FIRST BAPTIST CHURCH OF THEODORE
SUBDIVISION, RESUBDIVISION OF LOT 2,
RESUBDIVISION OF PARCEL A

FINAL PLAT COMMENTS (should be addressed prior to submitting the FINAL PLAT for review and/or signature by the City Engineer):

APPLICATION NUMBER 6 DATE April 5, 2018
 First Baptist Church of Theodore Subdivision, Resubdivision

DETAIL SITE PLAN

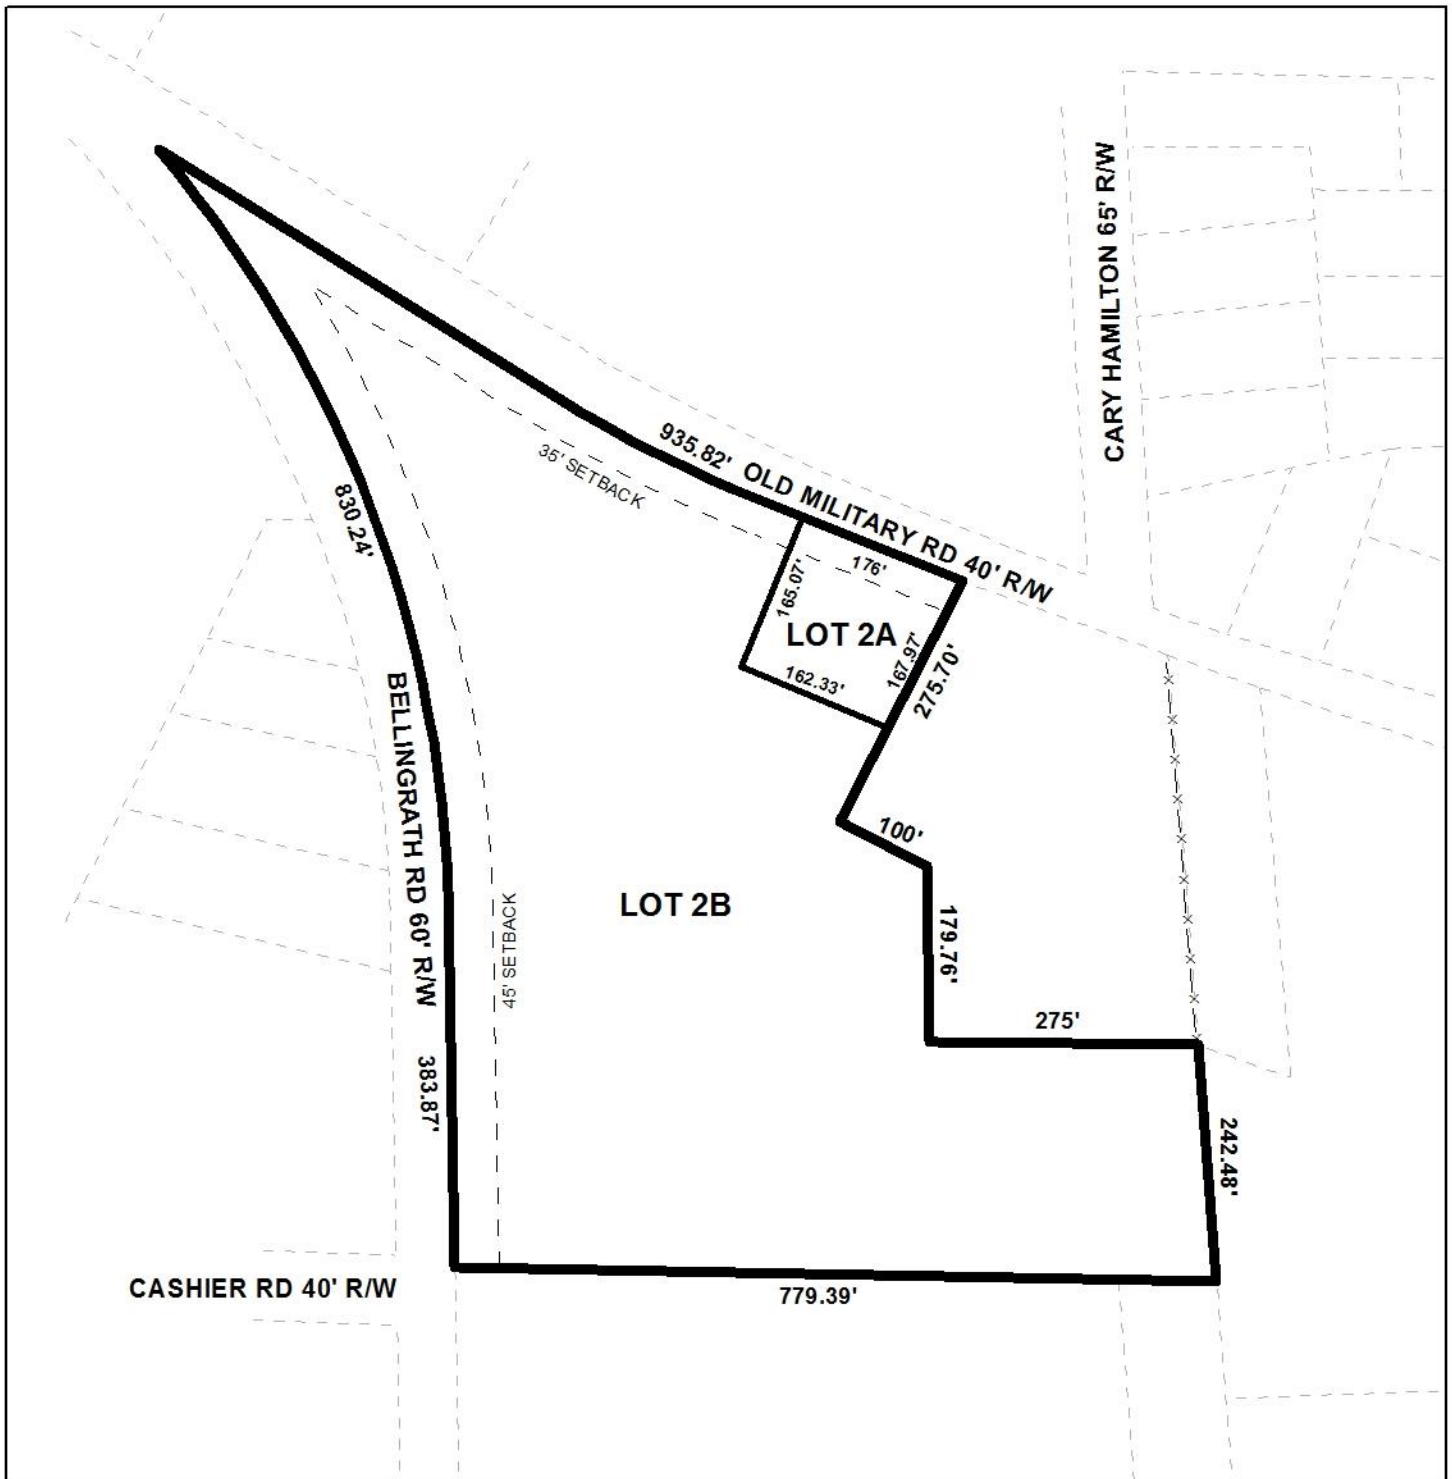
- A. REMOVE THE MOBILE COUNTY ENGINEERING DEPARTMENT NOTE. THIS PROPOSED SUBDIVISION IS LOCATED WITHIN THE CITY LIMITS. THE COUNTY ENGINEER NO LONGER SIGNS PLATS WITHIN THE MUNICIPAL LIMITS OF THE CITY OF MOBILE.

- B. Provide all of the required information on the SUBDIVISION PLAT (i.e. signature blocks, signatures, certification statements, written legal description, required notes, legend, scale, bearings and distances) that is required by the current Alabama State Board of Licensure for Professional Engineers and Land Surveyors.

- C. Provide the Surveyor's, Owner's (notarized), Planning Commission, and Traffic Engineering signatures.
- D. Add a note to the SUBDIVISION PLAT stating that a Land Disturbance permit will be required for any land disturbing activity in accordance with Mobile City Code, Chapter 17, Storm Water Management and Flood Control); the City of Mobile, Alabama Flood Plain Management Plan (1984); and, the Rules For Erosion and Sedimentation Control and Storm Water Runoff Control.

- E. Add a note to the Plat stating that the approval of all applicable federal, state, and local agencies (including all storm water runoff, wetland and floodplain requirements) will be required prior to the issuance of a Land Disturbance permit.

- F. Add a note that sidewalk is required to be constructed, and/or repaired, along the frontage of each lot, or parcel, at time of new development or construction, unless a sidewalk waiver is approved.

- G. Add a note to the plat stating that all easements shall remain in effect until vacated through the proper Vacation process.
- H. Provide a copy of the FINAL SUBDIVISION PLAT to the Engineering Dept. for review. No signatures are required on this drawing.

The proposed lot fronts Old Military Road and Bellingrath Road. Old Military Road is a minor street requiring a 60' right-of-way width and Bellingrath Road, a major street requires a 100'right-of-way width. As per the previously approved plat, the setback lines shown on the preliminary plat reflect additional setback in lieu of right-of-way dedication, due to existing development on the site.

The proposed lots exceed the 7,200 square foot minimum lot size requirements for lots served by public water and sanitary sewer systems. The preliminary plat provides the lot sizes in both square feet and acres. If approved, the lot size information should be retained on the Final Plat.

As a means of access management, a note should be placed on the Final Plat, if approved, stating that each lot is limited to its existing curb cuts, with size, location and design to be approved by Traffic Engineering and conform to AASHTO standards.

- 1) Retention of the 40' right-of-way width along Old Military Road;
- 2) Retention of the 60' right-of-way width to Bellingrath Road;
- 3) Retention of the 35' minimum building setback along Old Military Road;

- 4) Retention of the 45' minimum building setback along Bellingrath Road;
- 5) Retention of lot size information in both square feet and acres for proposed Lot 2-A and 2-B;

- 6) Placement of a note on the Final Plat stating that each lot is limited to its existing curb cut, with any changes in the size, design and location to be approved by Traffic Engineering and conform to AASHTO standards;
